Addendum No. 001 (CORRECTED)

Subject: Boiler Plant Replacement Bid Package
General, Mechanical, & Electrical
SDP Contract No. B-108c/109c/110c of 2017/18

Location: Mastbaum High School
3116 Frankford Avenue
Philadelphia, Pennsylvania 19134

This Addendum, dated May 09, 2019, shall modify and become part of the Contract Documents for the work of this project. Any items not mentioned herein, or affected by, shall be performed strictly in accordance with the original documents.

3 UNDERGROUND STORAGE TANK AND FUEL OIL PIPING NEW WORK PLAN
SCALE: 1/8" = 1'-0"

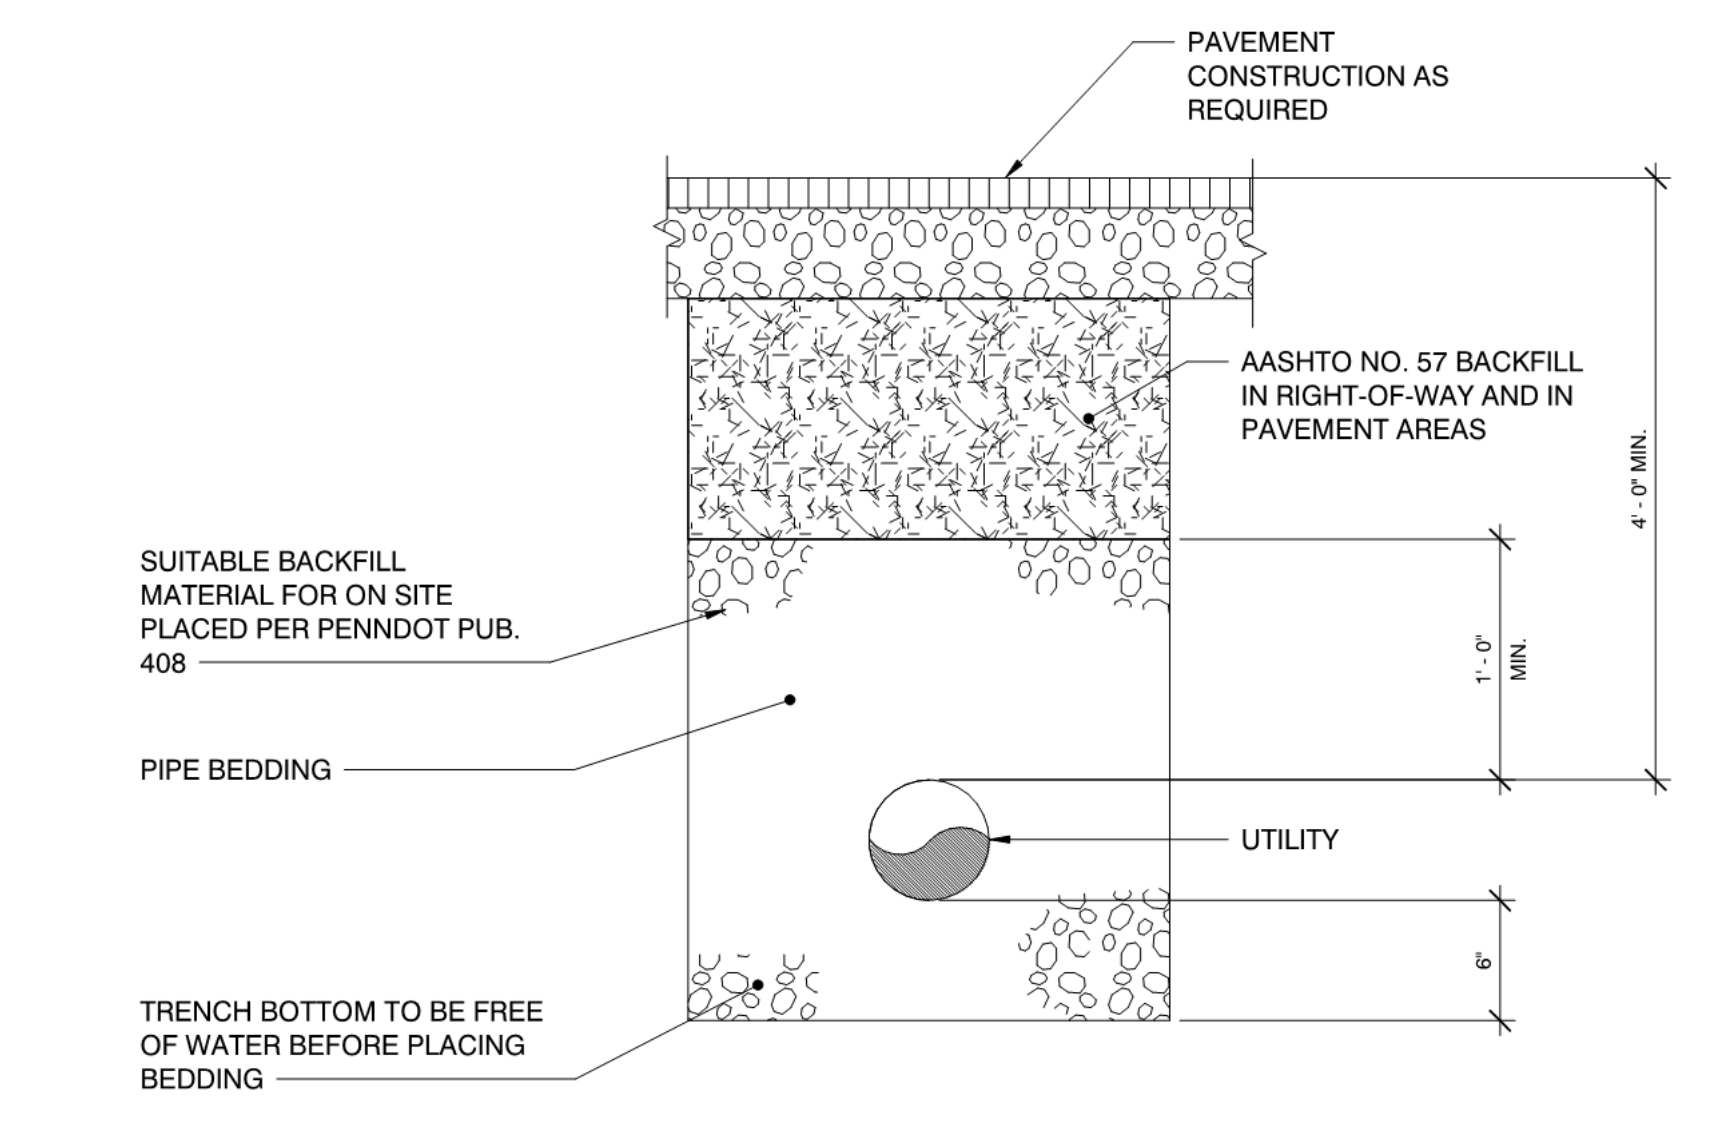
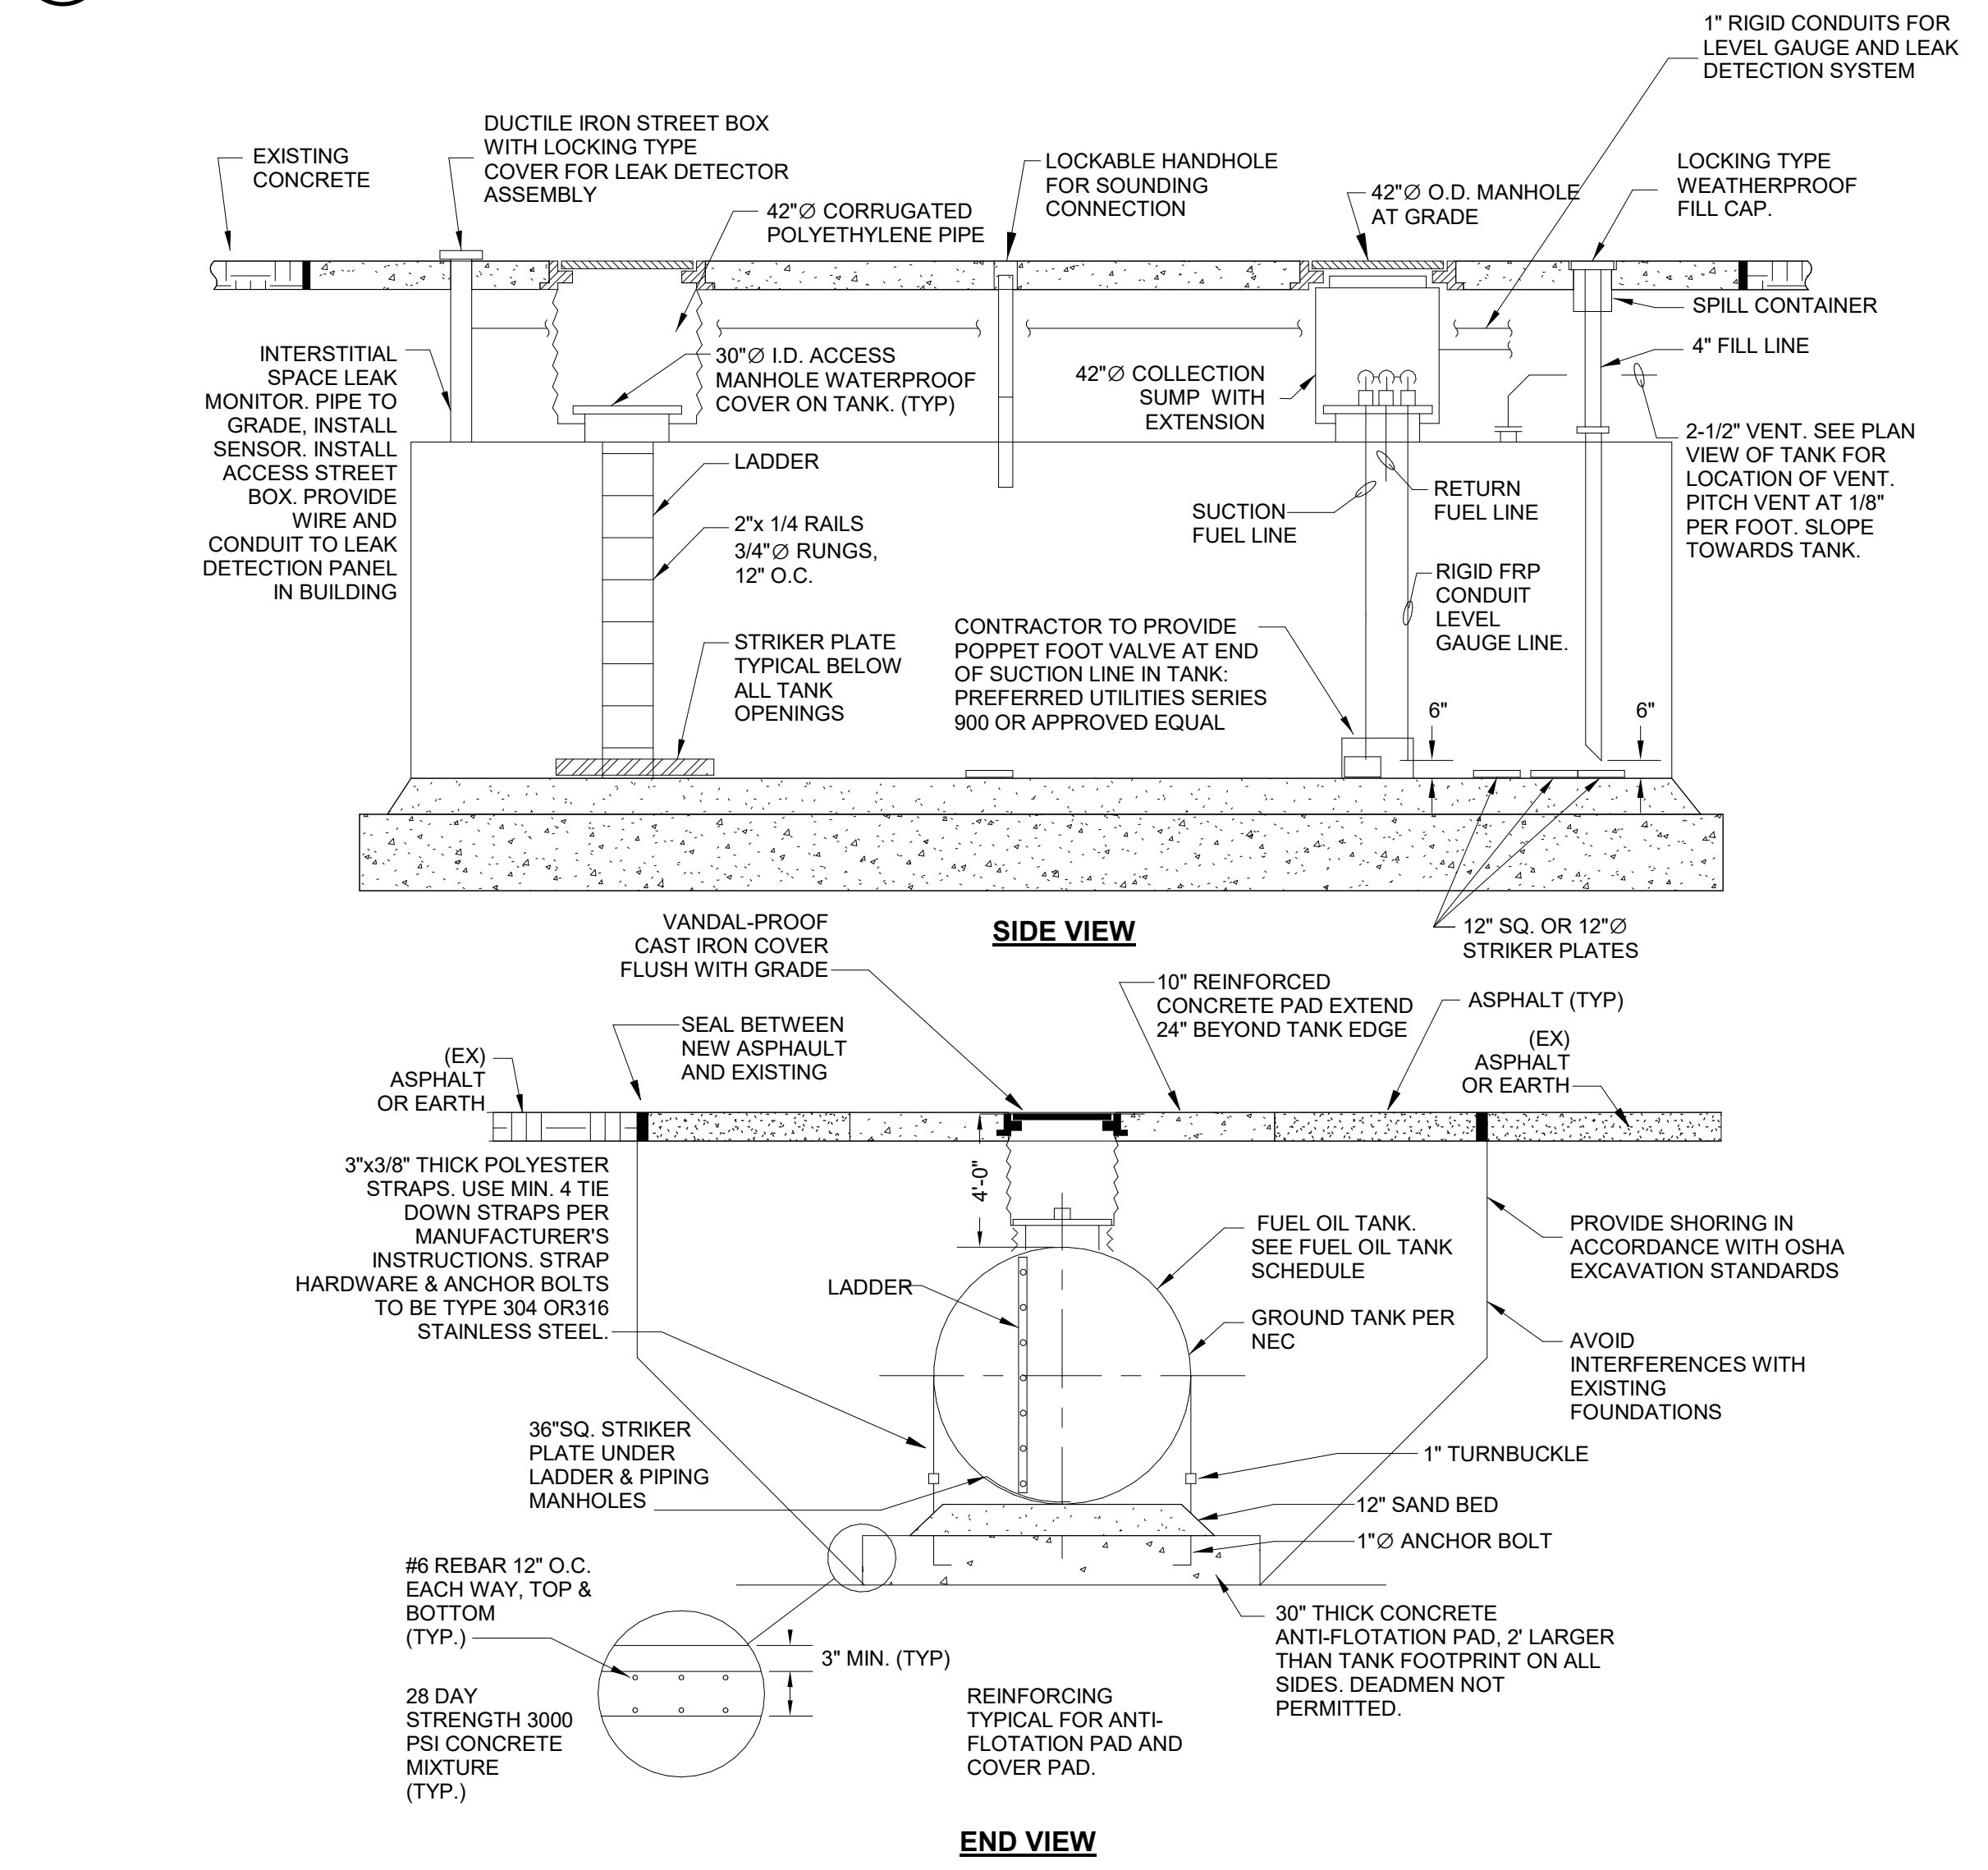
- 2.1.1 Drawing G-001: ADD Sheet P-102, Plumbing Fuel Oil Tank Demolition and New Work to the Drawing Index as Sheet 19A.

- 2.1.10** REPLACE P-101 with Addendum 001 Version. [See attached]
- 2.1.11** ADD Drawing P-102, Plumbing Fuel Oil Tank demolition and New Work [See attached]

- 2.1.12** Drawing E-401: ADD 120V wiring and conduit circuit from the remote overflow alarm panel to Panel PPBA. Refer to P-102.
- 2.1.13** Drawing E-401: ADD 120V wiring and conduit circuit from the level control system and secondary containment leak detection panel to PPBA. Refer to P-101.

**MECHANICAL NEW WORK CENTRAL AND EAST MECHANICAL ROOMS ENLARGED
PLAN BELOW 11'6"**
SCALE: 1/4" = 1'-0"

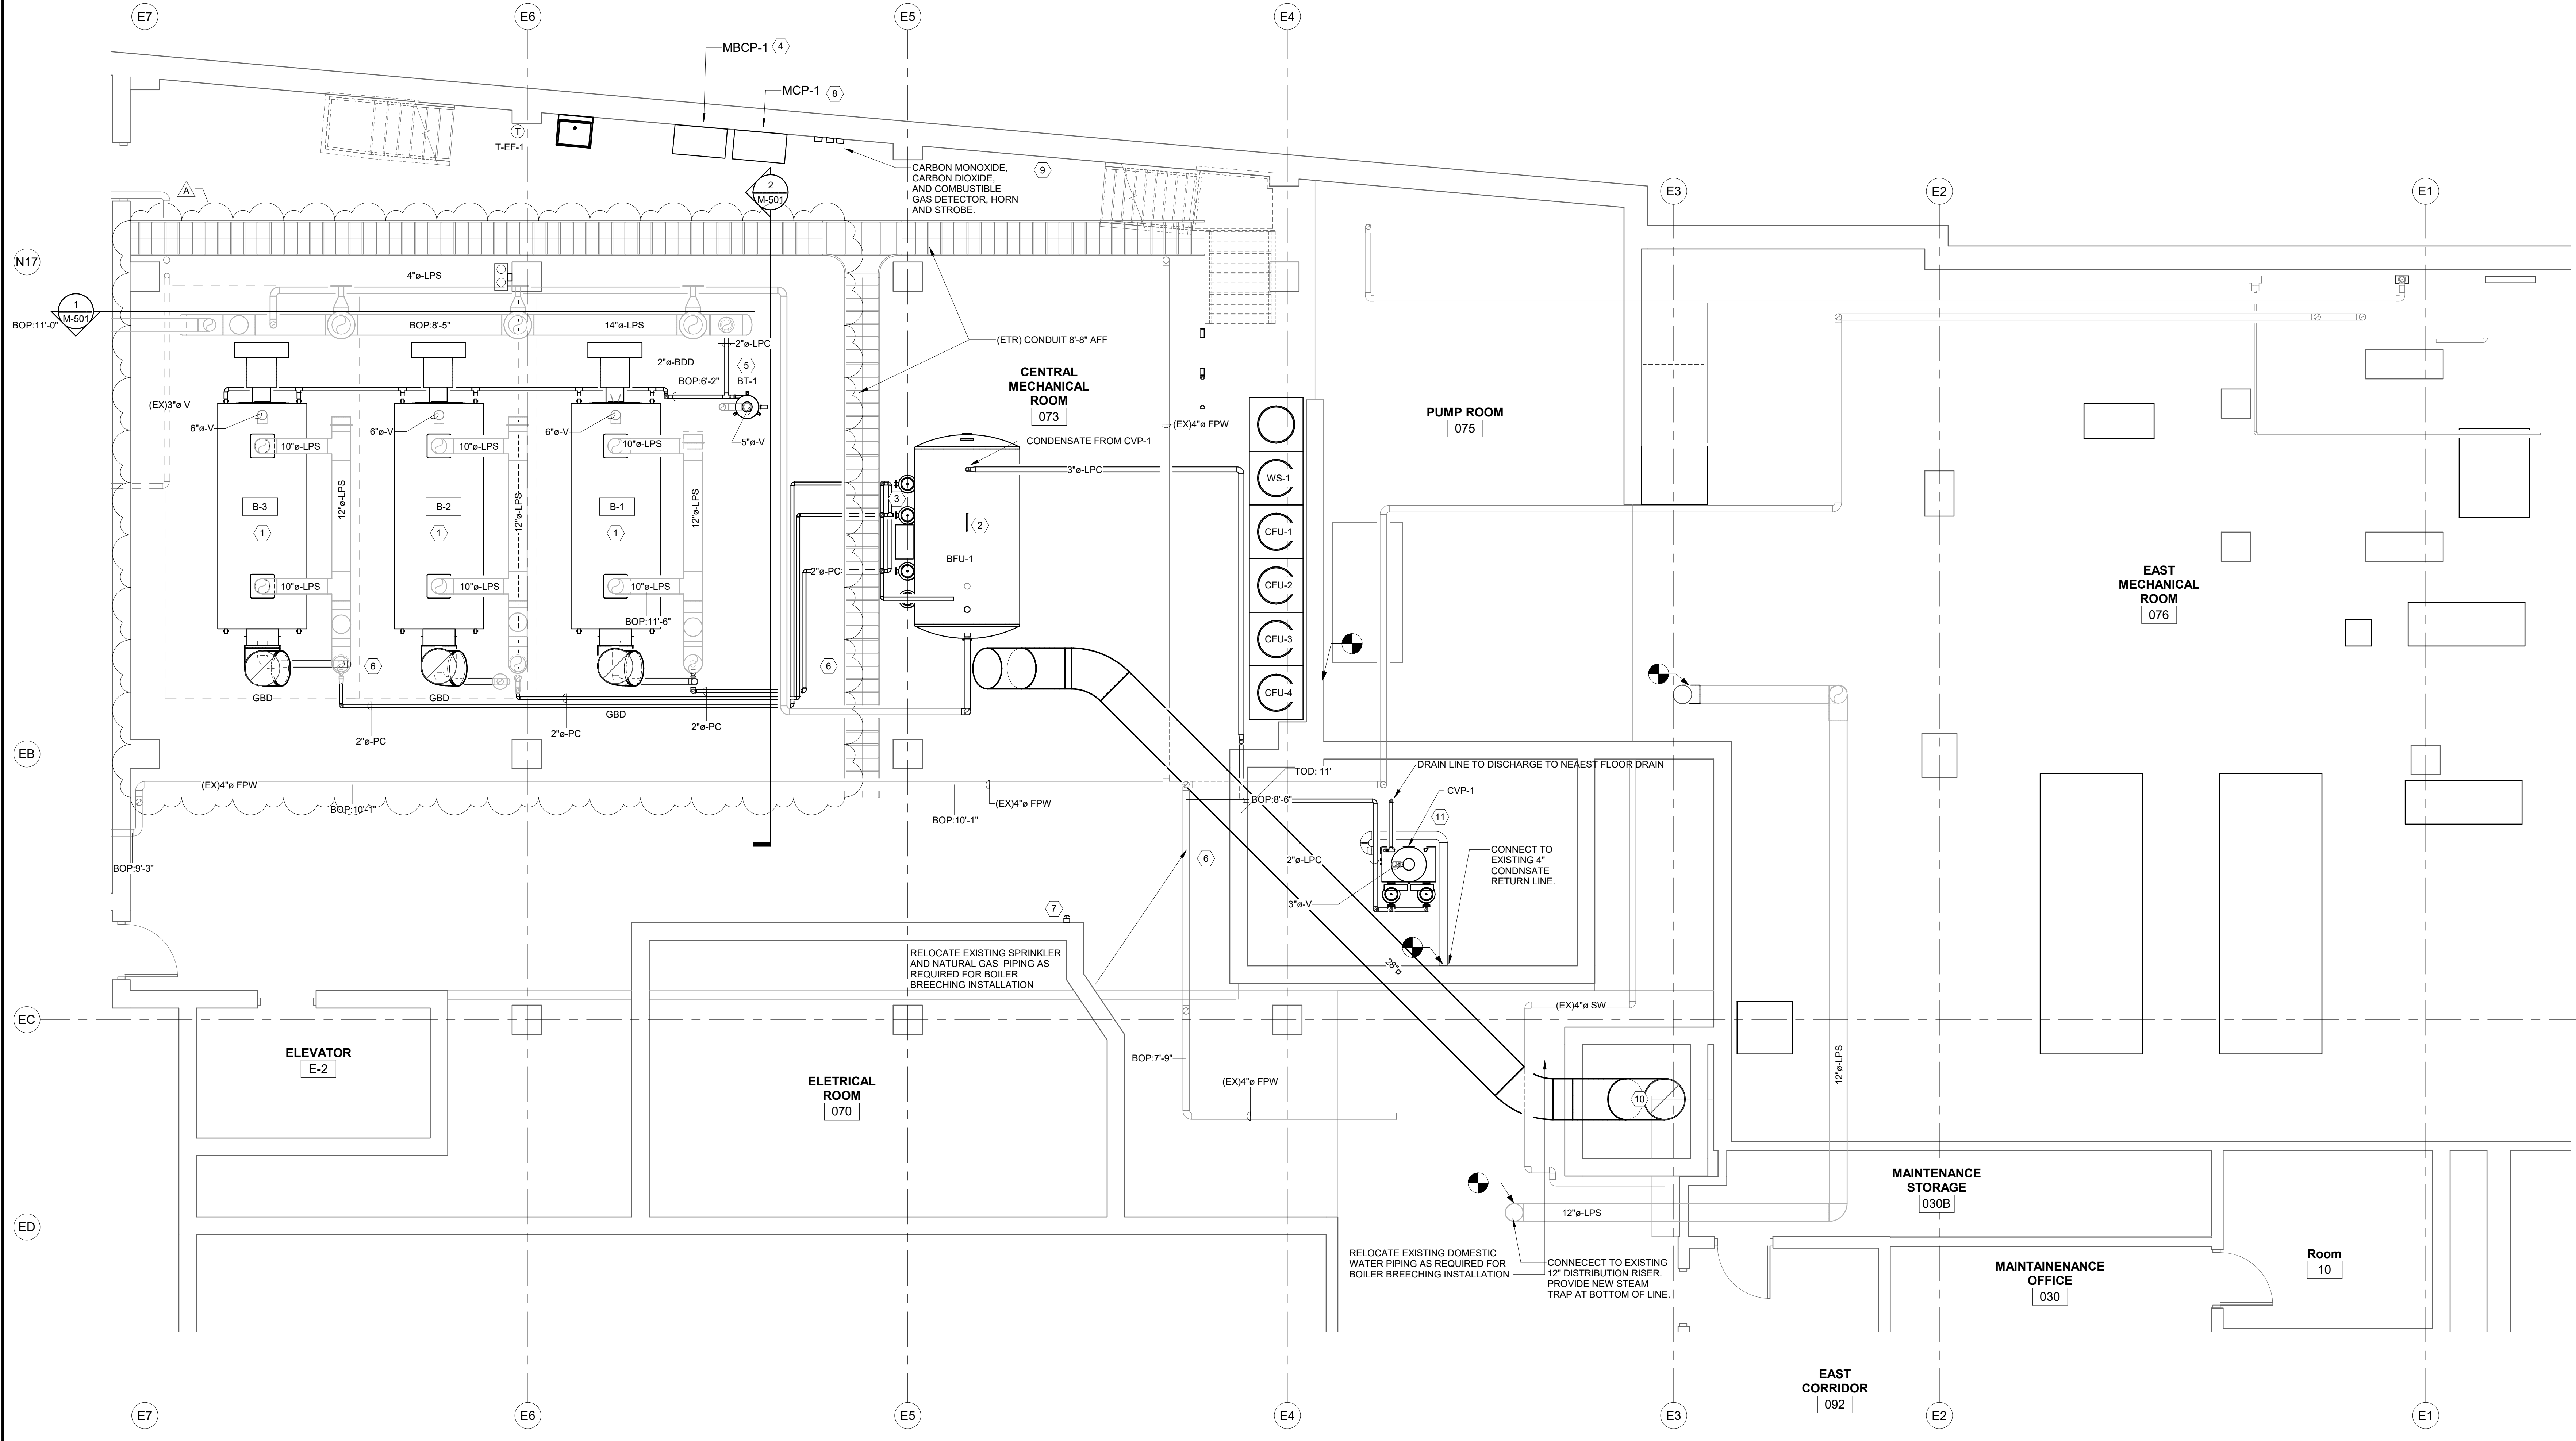
- 3.1.9** Drawing M101 note #15 states to remove all piping in their entirety but Drawing M402 shows to connect 8" steam piping to existing 14" LPS main. It also shows new connections from the new boilers to the existing 12" LPS main. Which is correct?

RESPONSE: The referenced clerical errors of Sheet M-402 have been corrected. See attached.
